**Re: Ridgeview Addition– Drainage Study in support of the Preliminary Plat - First Review**

Halff Associates, Inc. was requested by the City of Sanger to provide a review of the drainage study and downstream assessment in support of the preliminary plat for the Ridgeview Addition development. The drainage study prepared Allison Engineering Group was received on November 21, 2022.

AL ESTATE  
PLANS  
ADDITION  
ON COUNTY, TEXAS  
INVESTMENT  
CONSTRUCTION  
RIDGEVIEW  
CITY OF SANGER, TEXAS  
DETENTION POND PLAN

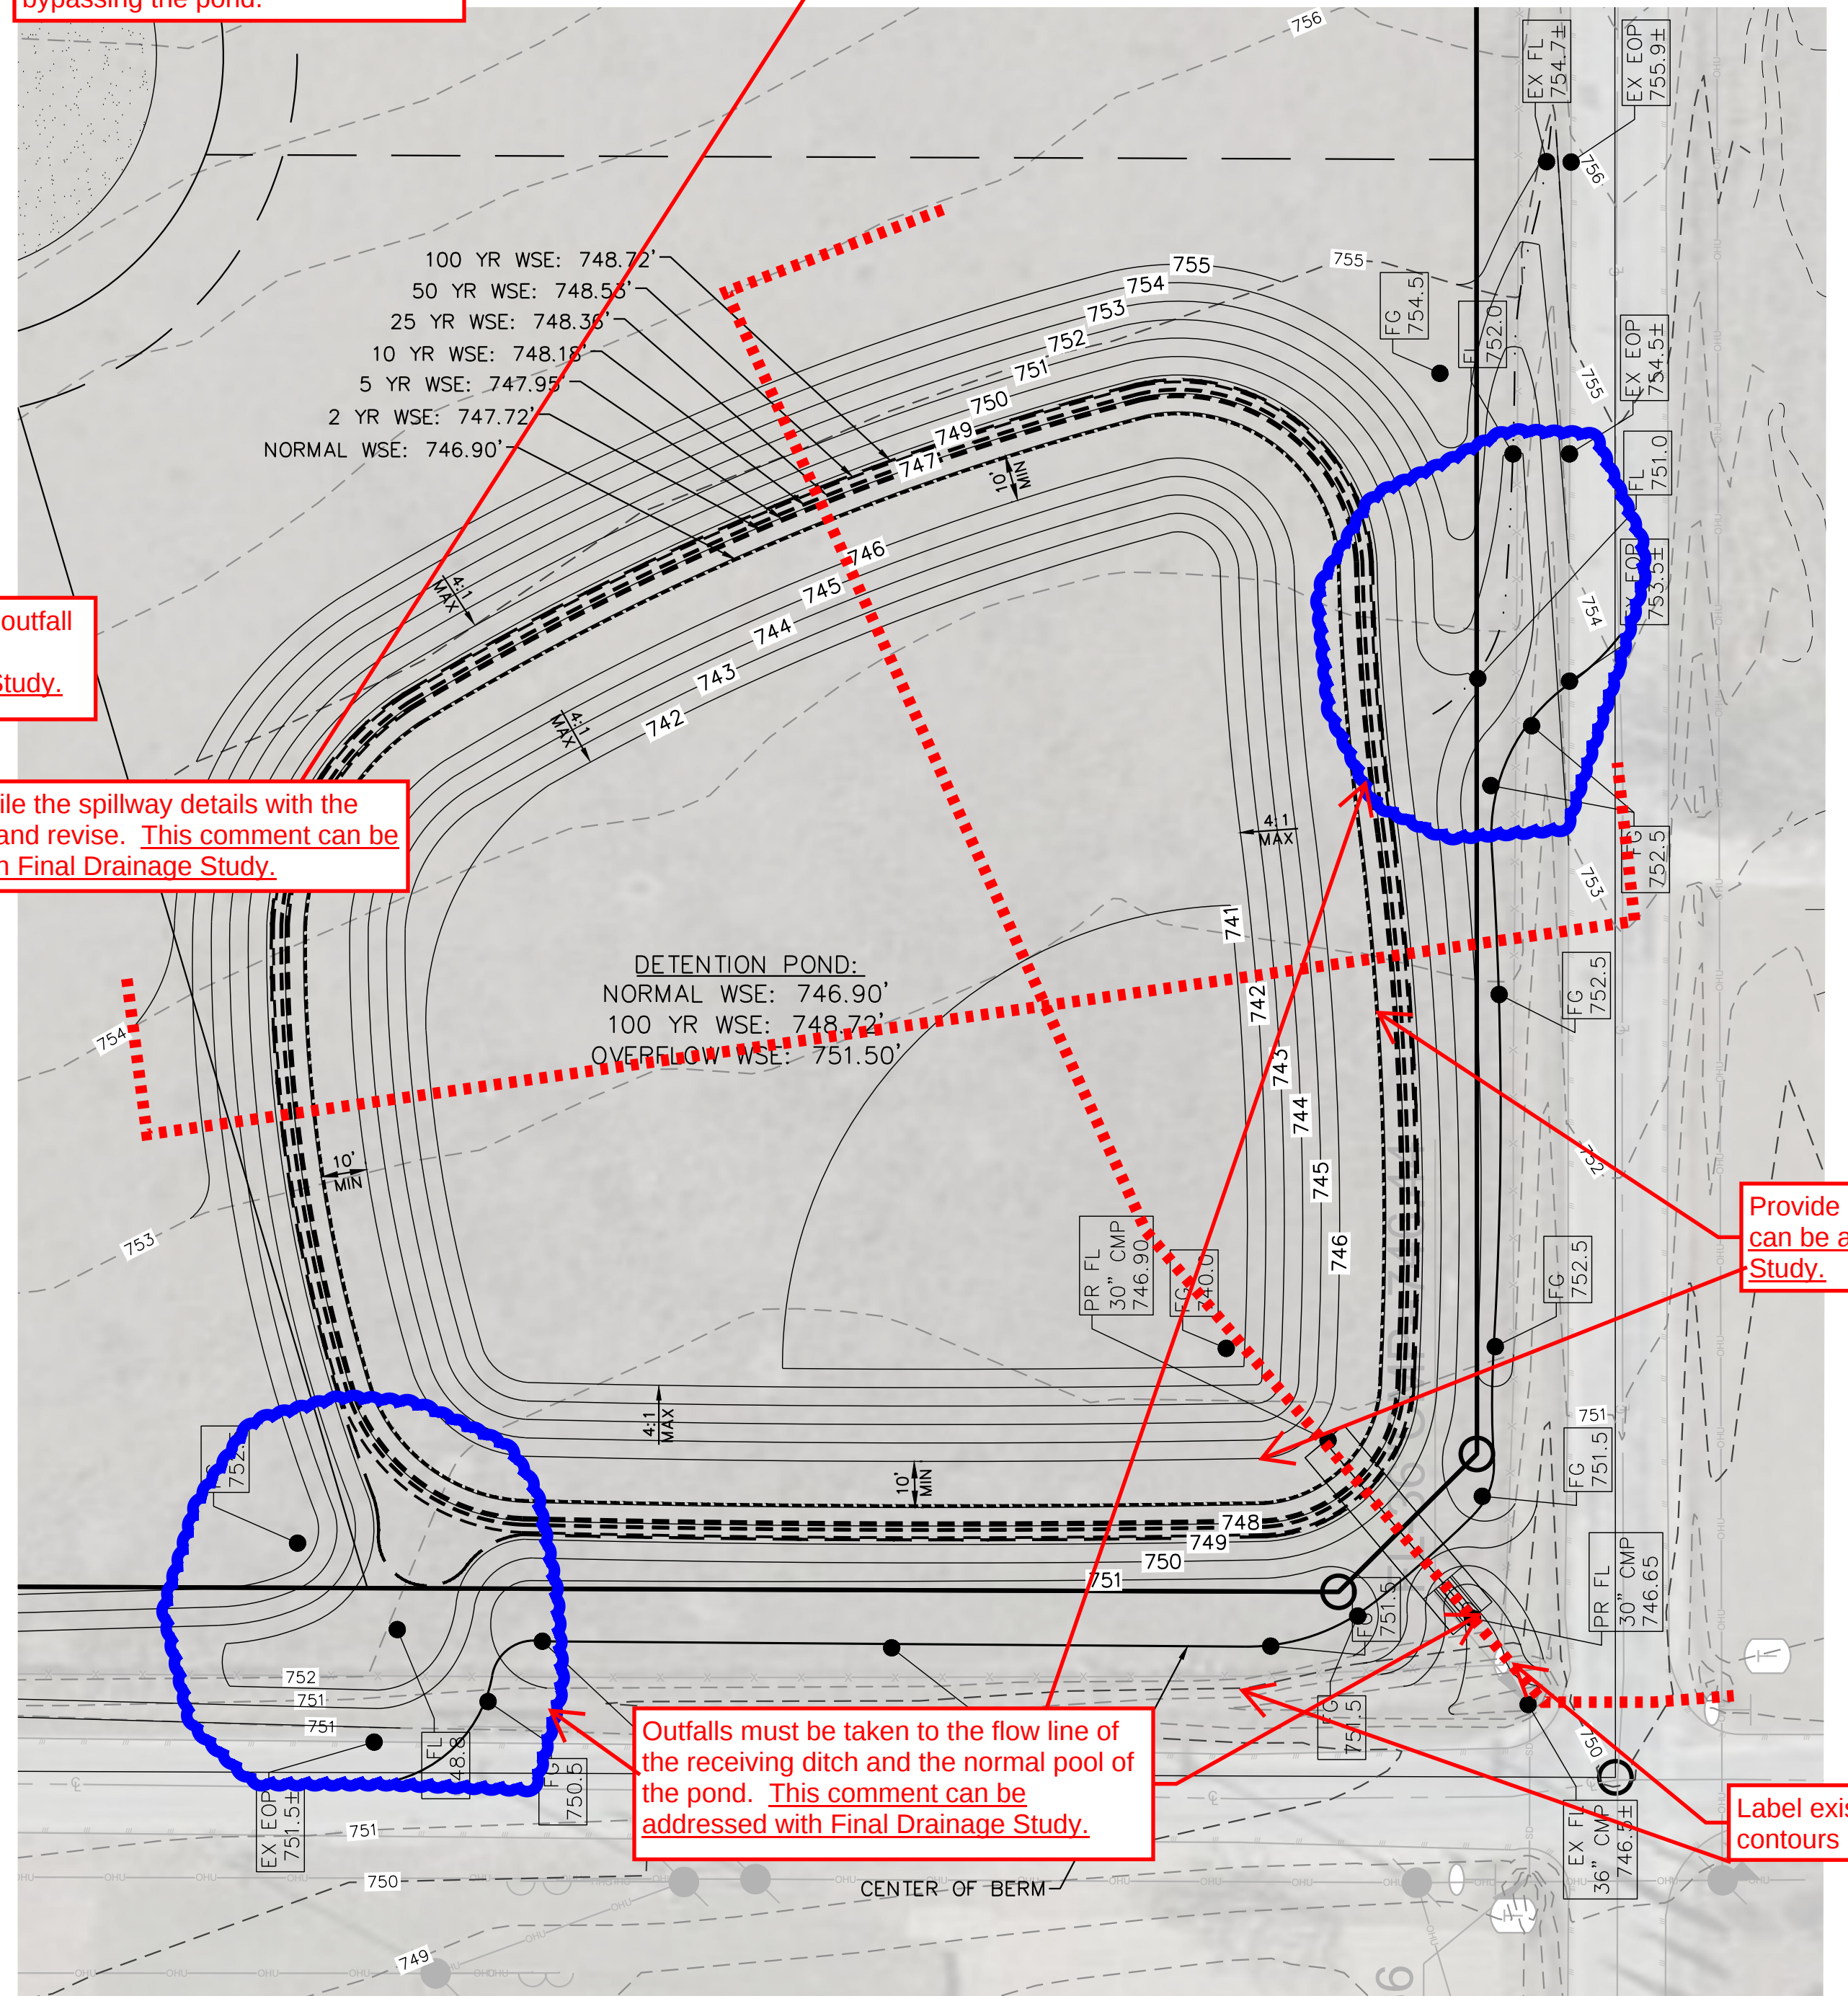
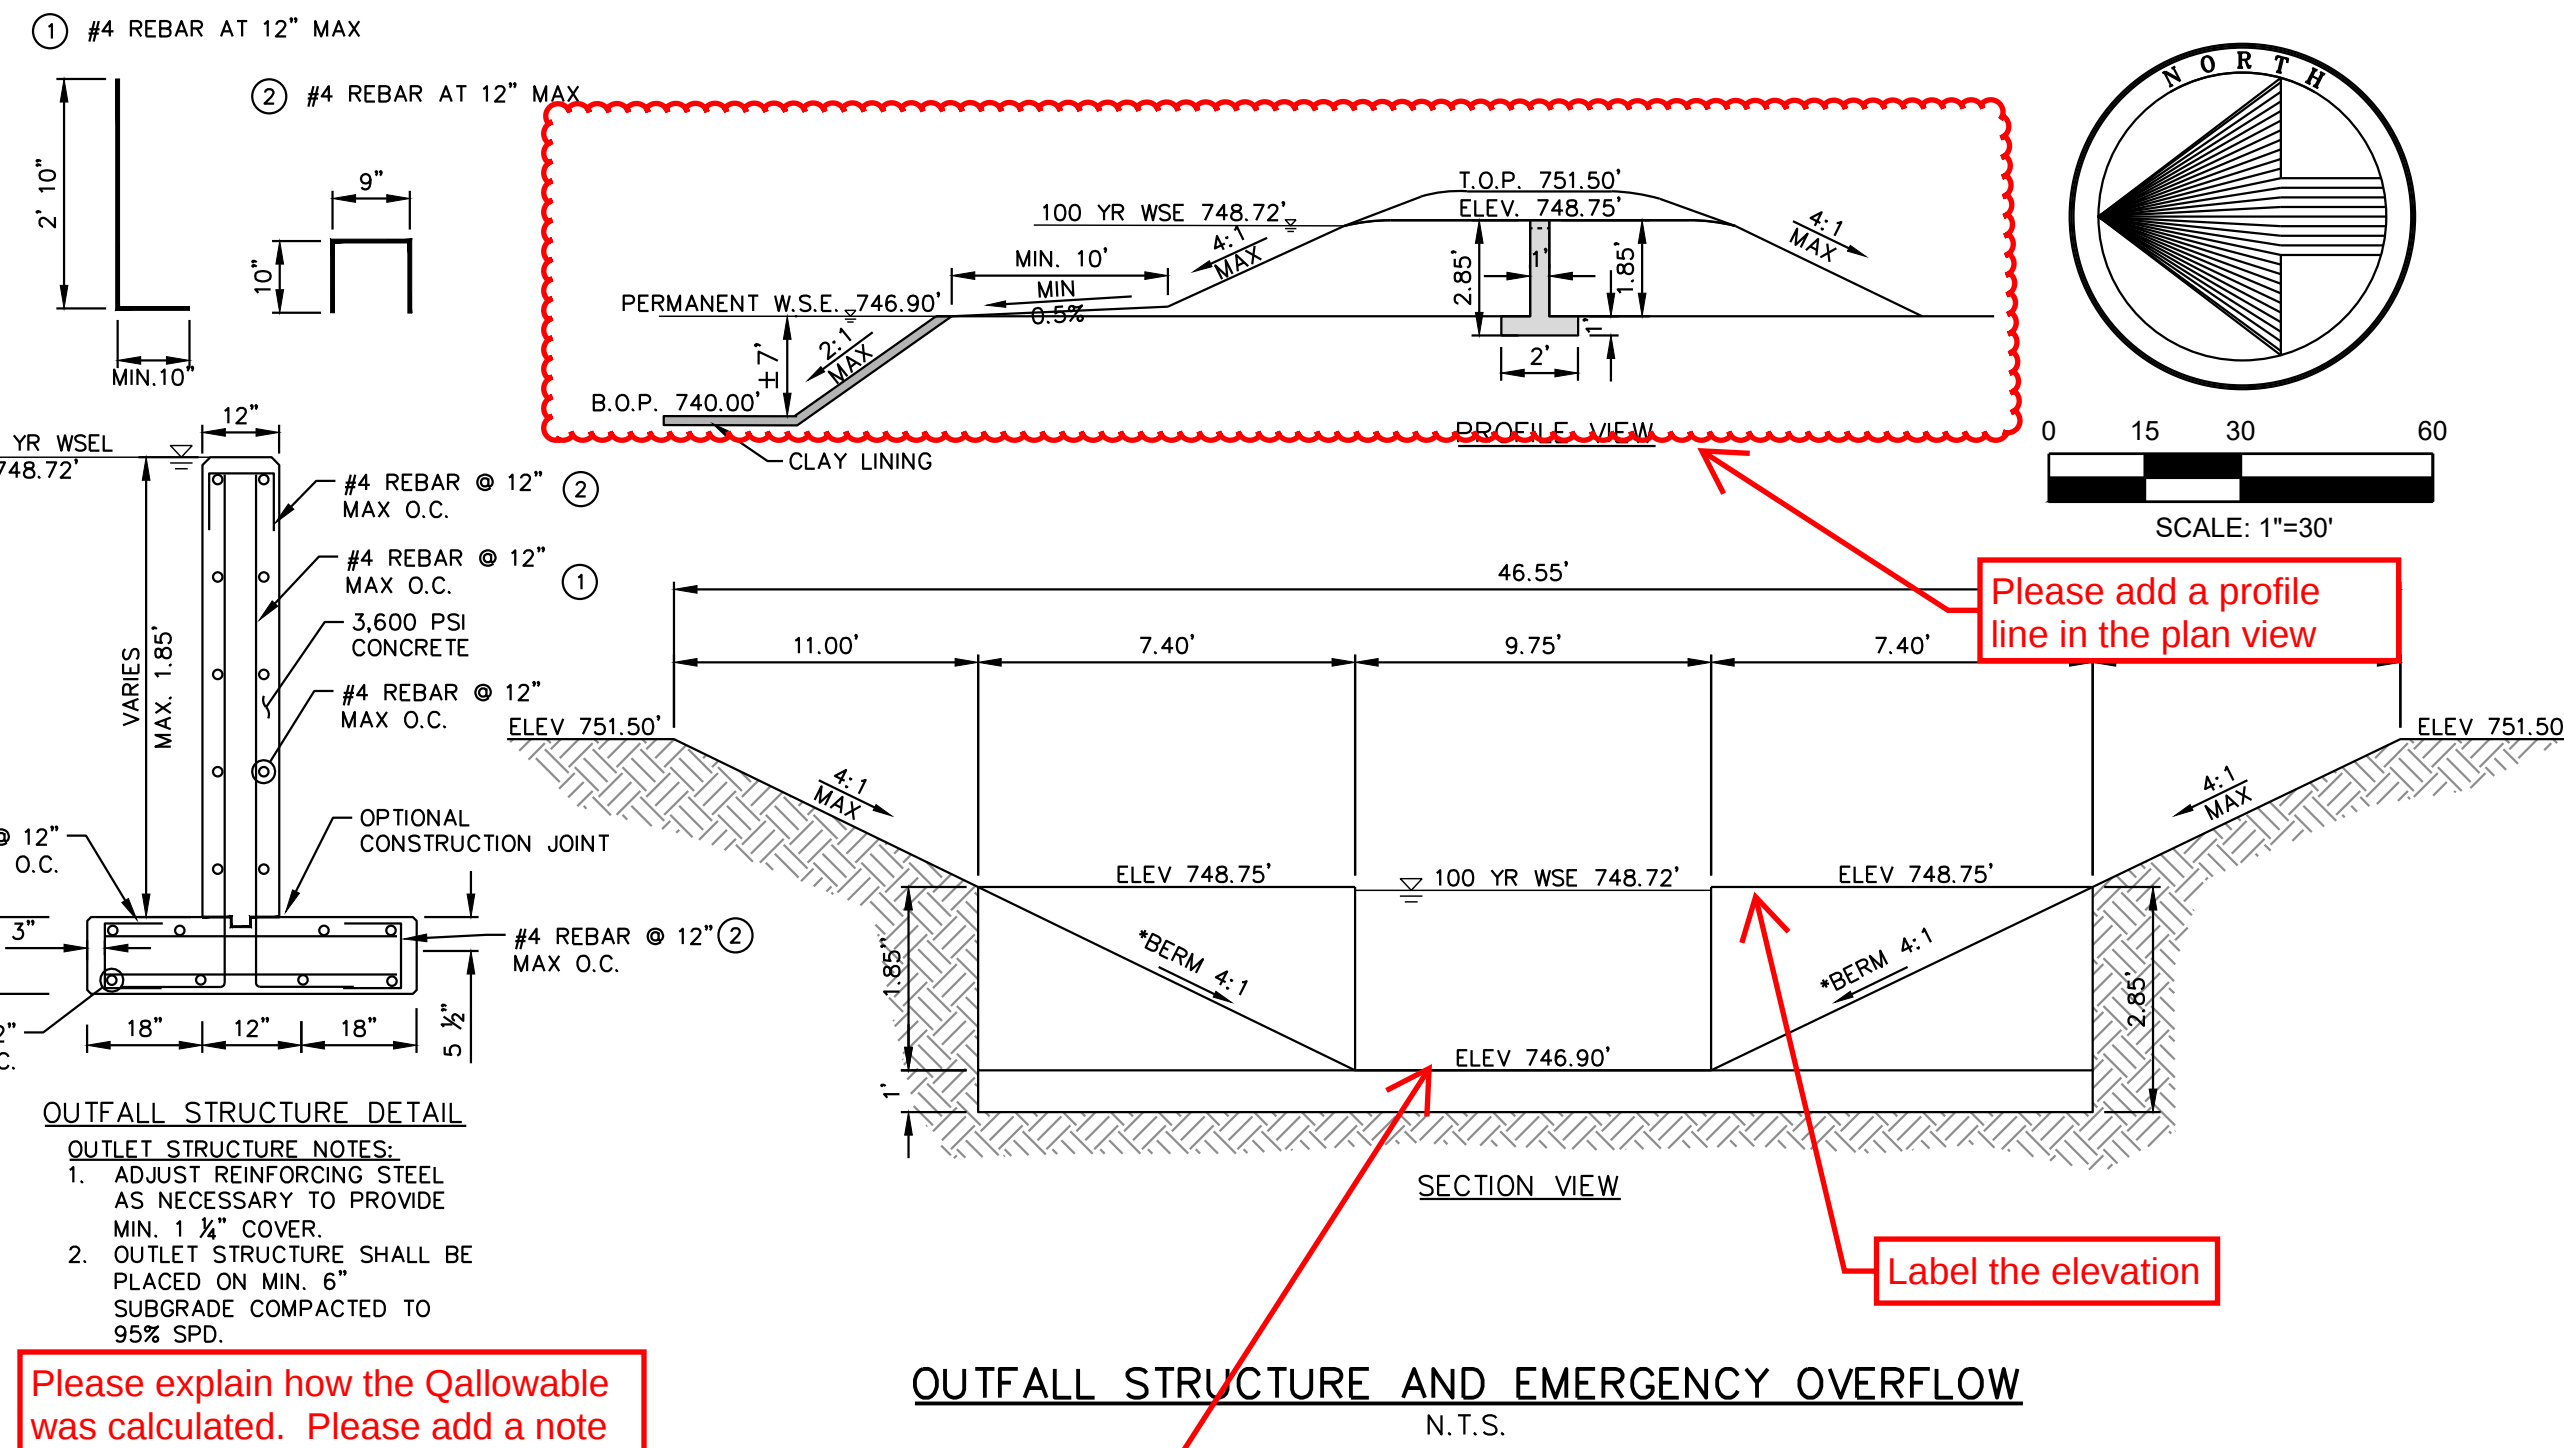
Provide structural details for the outfall structure. This comment can be addressed with Final Drainage Study.

Please reconcile the spillway details with the model details and revise. This comment can be addressed with Final Drainage Study.

Please explain how the Qallowable was calculated. Please add a note below the chart to indicate areas draining to the pond and the areas bypassing the pond.

Outfalls must be taken to the flow line of the receiving ditch and the normal pool of the pond. This comment can be addressed with Final Drainage Study.

Provide cross-sections. This comment can be addressed with Final Drainage Study.
